PURCHASING OFFICE
800 College Court
New Bern, NC 28562
Phone: (252) 638-7263
murphret@cravencc.edu
www.CravenCC.edu

RFP ADDENDUM

RFP Number: 92-26-006 Commodity: 461716 Surveillance and detection equipment
Addendum No.: 2

Brock 1st Floor

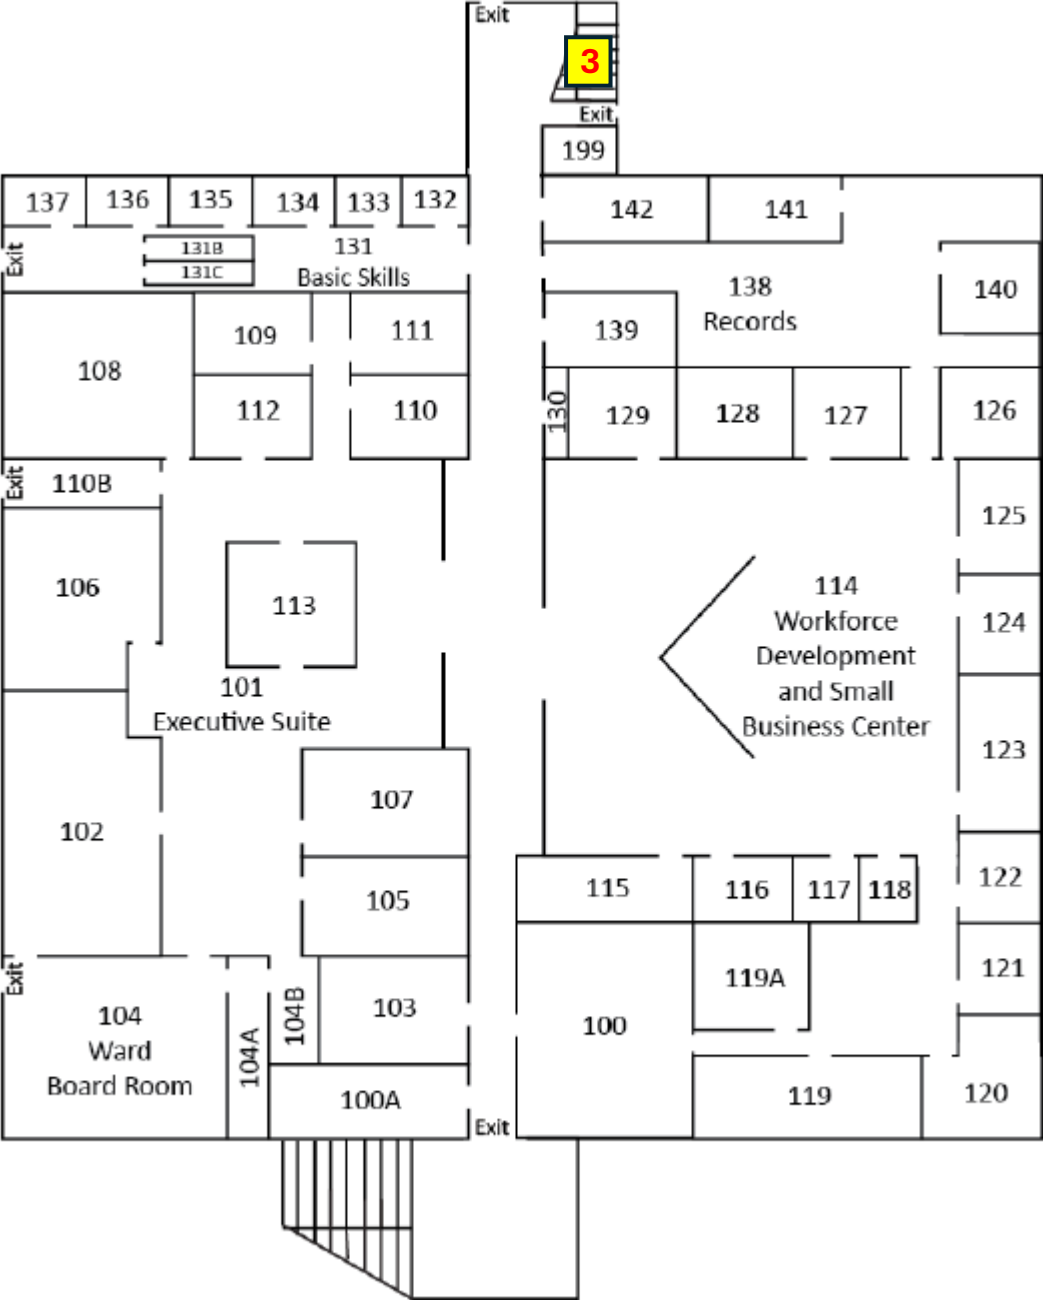
Question: Please provide the exact list of the 17 interior cameras included in Alternate 01 (building + camera number), as referenced in the Campus Camera Locations.

- a. Brock 1st Floor: Camera 3
- b. Brock 2nd Floor: Camera 8
- c. Ward: Camera 14
- d. Orringer: Cameras 6, 7, 8, 9
- e. Bate 2nd Floor: Cameras 5, 6, 8, 11
- f. Bosch: Camera 9
- g. Havelock IAT: Camera 8
- h. Volt Taylor Hall: Cameras 5
- i. Volt Taylor Hall Basement: Cameras 1, 2, 3
